MIL-PRF-19500/673
AMENDMENT 2
6 May 2002
SUPERSEDING
AMENDMENT 1
20 August 2001

PERFORMANCE SPECIFICATION

SEMICONDUCTOR DEVICE, FIELD EFFECT RADIATION HARDENED
(TOTAL DOSE AND SINGLE EVENT EFFECTS)
TRANSISTOR, N-CHANNEL, SILICON TYPES 2N7468U2 AND 2N7469U2
JANTXVR, F, G, AND H, AND JANSR, F, G, AND H

FIGURE 2. Thermal response curve. "

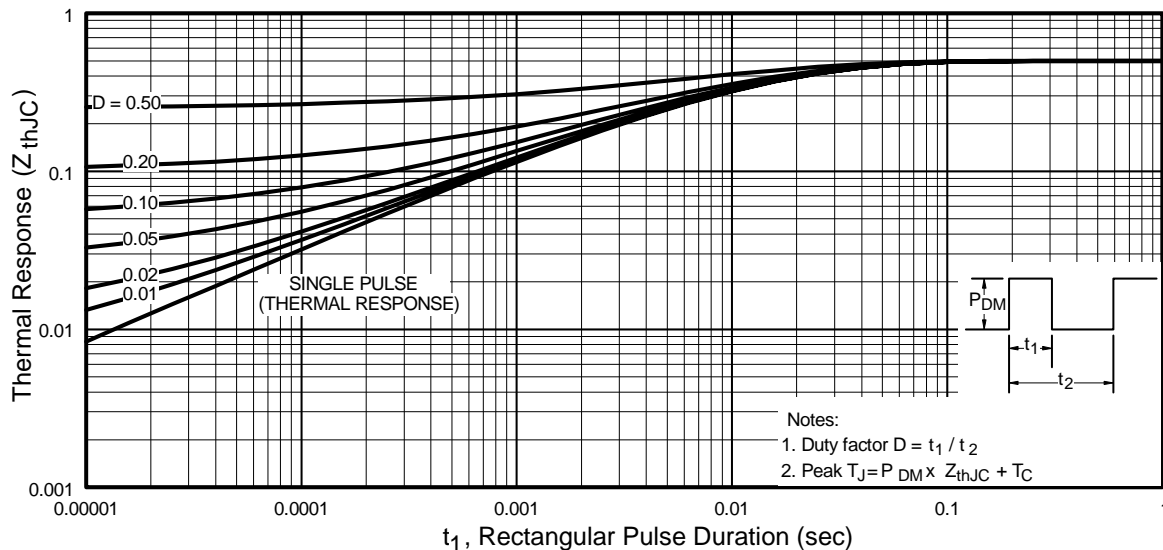
FIGURE 2, delete and substitute:

FIGURE 3. Safe operating area graph. "

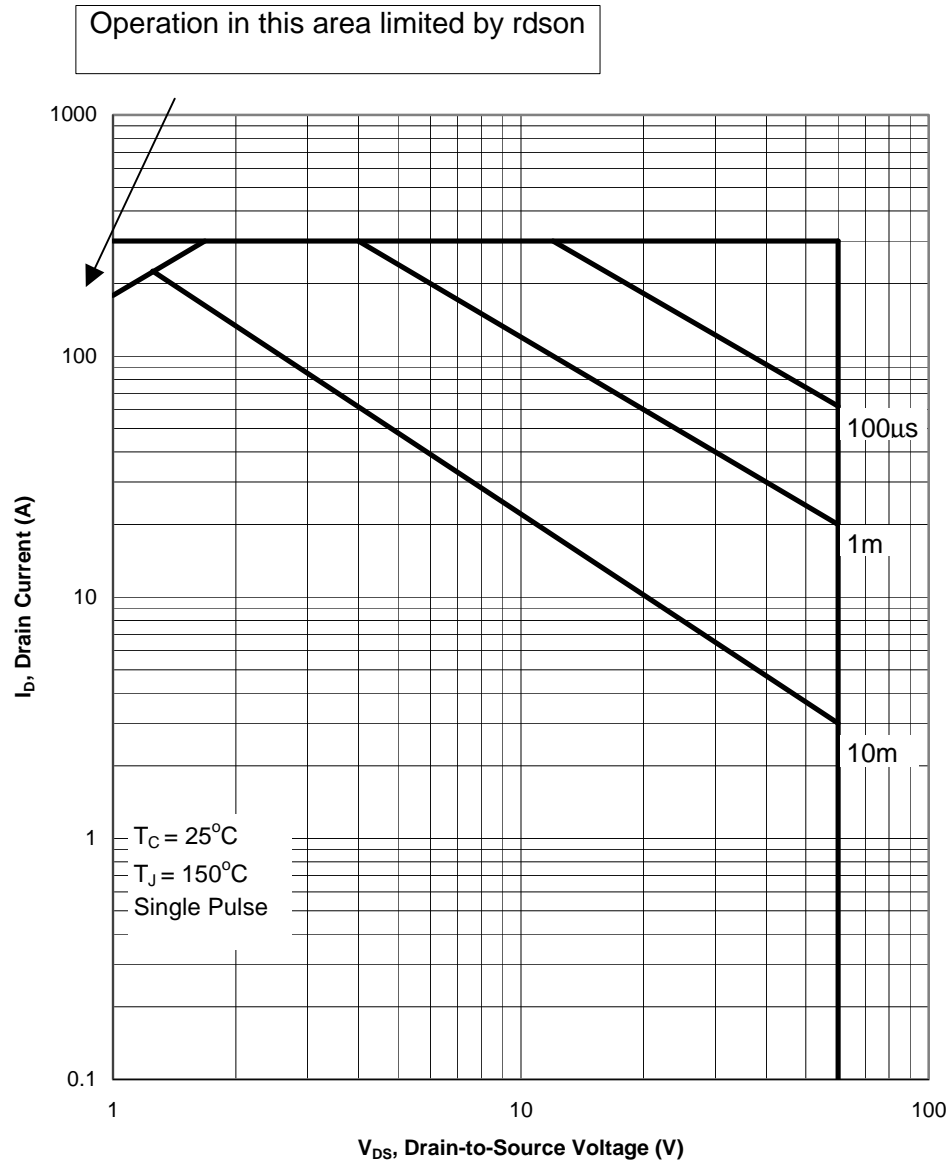
FIGURE 3, delete and substitute:
"

FIGURE 4. Safe operating area graph. "

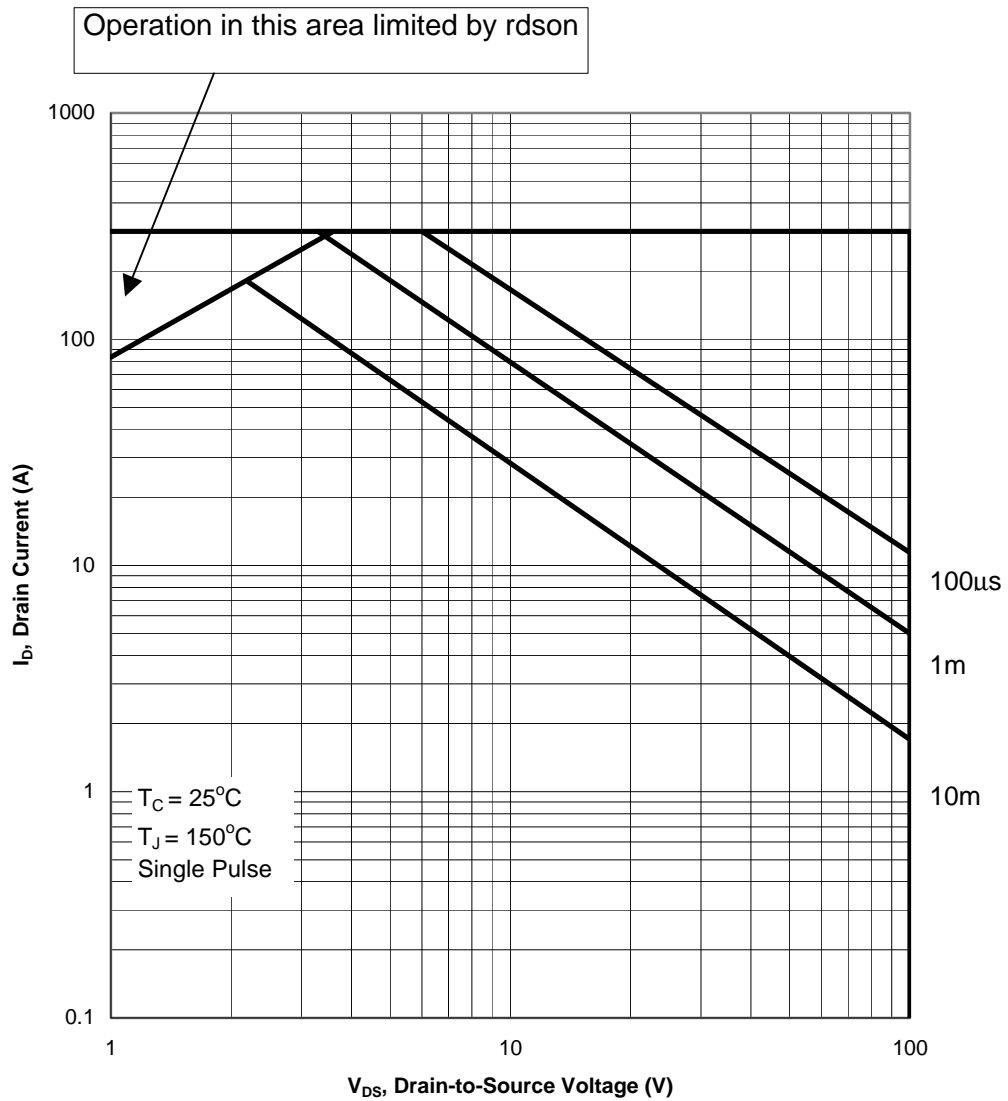
FIGURE 4, delete and substitute:
"

FIGURE 5. SEE safe operating area graph. "

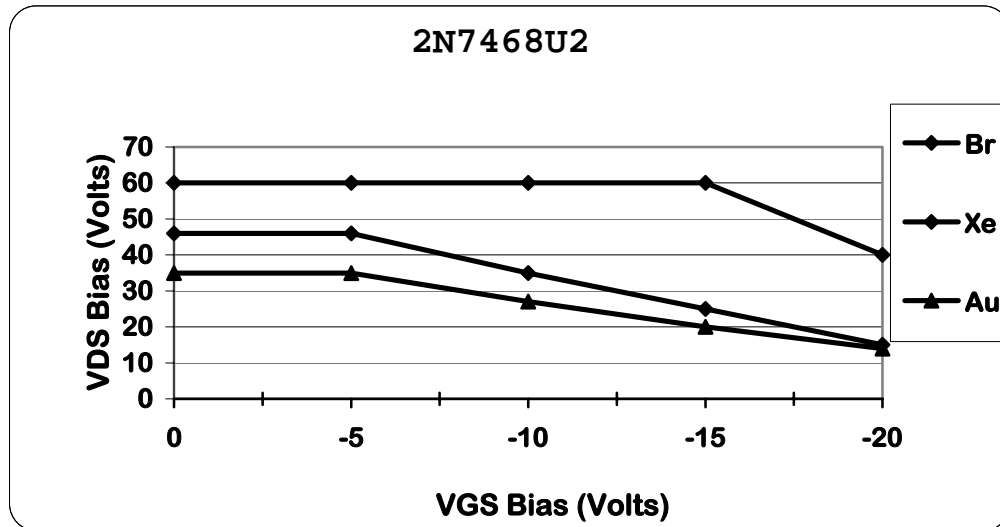
FIGURE 5, delete and substitute:
“
